**AGENDA
CITY OF CREVE COEUR
PLANNING AND ZONING COMMISSION
300 NORTH NEW BALLAS RD
FEBRUARY 17, 2026
6:00 PM**

APPLICATION TO PLANNING AND ZONING COMMISSION #26-002: AN APPLICATION FOR A SITE DEVELOPMENT PLAN FOR RESIDENTIAL SUBDIVISION ENTRY SIGNS FOR THE CHAMINADE PARK SUBDIVISION LOCATED AT BOTH ENTRANCES ON S. SPOEDE ROAD

REPORT PREPARED BY: Bethany L. Moore, AICP, City Planner
DATE: 2/11/2026
ATTACHMENTS: Applicant's Materials received Feb 2, 2026

Figure 4: Proposed refaced entry monuments and signage.

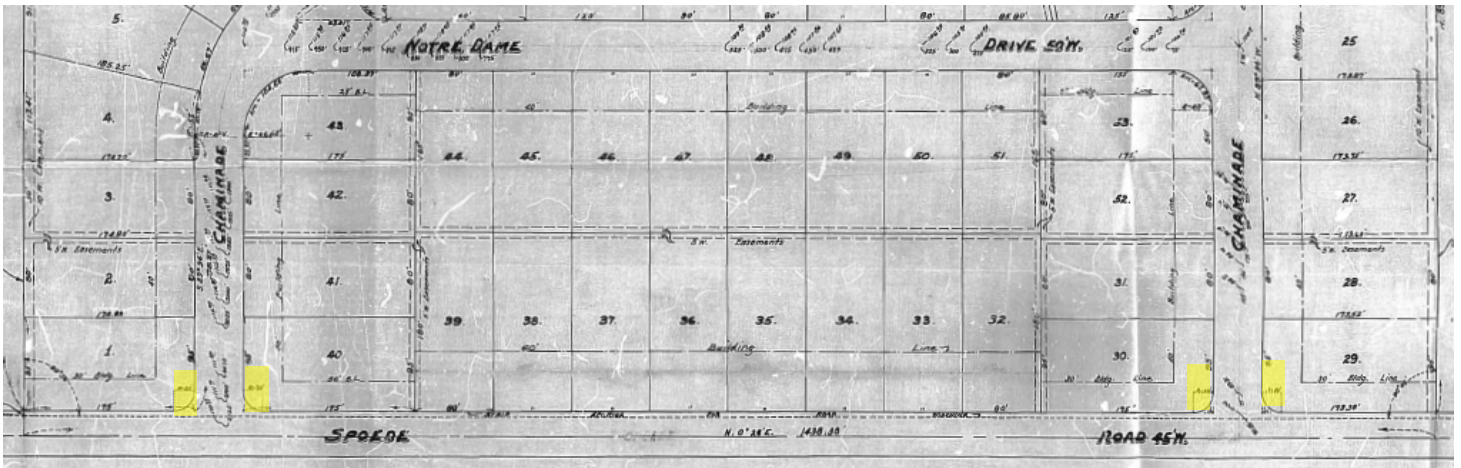
Section 405.940 *Residential Development Signs* allows for permanent signage for subdivisions, neighborhoods or multi-family developments through Planning and Zoning Commission review and approval of a site development plan. Signs are limited to 12 square feet per sign face and a maximum of 2 sign faces. The proposal includes four new signs, one on each entrance monument, which will be just under 12 square feet each. There are two existing wrought iron signs, one at each entrance, that the applicants would like to leave in place. Although Section 405.940 does not limit the amount of residential development signage, typically entry monuments are not accompanied by additional neighborhood signage. The Commission should discuss the request for the existing signage to remain with the applicant.

There is currently no existing landscaping around the entry monuments; however, Google Street View does show vegetation around the signs in previous years. The application does not include planned landscaping, but landscaping is typically requested by Staff for neighborhood entrance monuments and is a common component for these types of signs. Staff recommends that some form of landscaping be provided to soften the appearance of the monument signs in order to be cohesive with other subdivision monument signs throughout the city. A condition of approval has been added for a landscaping plan to provide plantings around the base of the sign to be provided for staff review and approval before a sign permit can be approved.

Staff has provided conditions for approval that will need to be met before sign permits can be issued. The Commission should also consider the request to allow the existing wrought iron-style pole signs to remain in addition to the proposed new signage. Such a condition should be added to the suggested conditions below.

1. The Applicant shall follow the Site Development Plan received February 4, 2026 for the sign reface for the subdivision entrance monuments, as approved by the City of Creve Coeur, except as modified below. The location, size, shape, color, type, and design of each sign shall not substantively depart from the Site Development Plan, unless approved by the City of Creve Coeur.

2. The applicant shall obtain approval of sign permits for the proposed sign refacing as shown in the Site Development Plan and as approved by the Planning and Zoning Commission prior to installation.

3. The Applicant shall provide a landscape plan for the monument signs that is consistent with landscaping provided for subdivision development signs throughout the city, that includes the use of native and evergreen plants, around the base of the sign for staff approval in conjunction with the sign permit.

4. The trustees are responsible for any necessary agreements with property owners for the installation, repair and maintenance of existing and proposed signs. Proof must be oprovided prior to issuance of permit.

5. No additional permanent signage is allowed for the neighborhood except as approved herein.
